Evaluation Kit for RA4L1 Microcontroller Group EK-RA4L1 v1 Errata

EK-RA4L1 v1

This Errata describes the known issues and deviations to the functional specifications for the EK-RA4L1 v1, the Evaluation Kit for the RA4L1 MCU Group. For additional information on the kit, see the EK-RA4L1 v1 User's Manual.

Figure 1. Debug in Connector

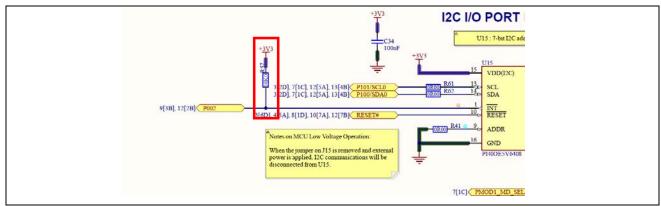
2.1 Port Expander Pull-up Resistor R57

The interrupt pin on the port expander (U15), is pulled up by +3.3V. While in low power mode (MCU Voltage < +3.3V), current will flow towards the interrupt pin.

Please remove R57 before running the EK-RA4L1 in low power mode.

This will be corrected on later versions of the kit.
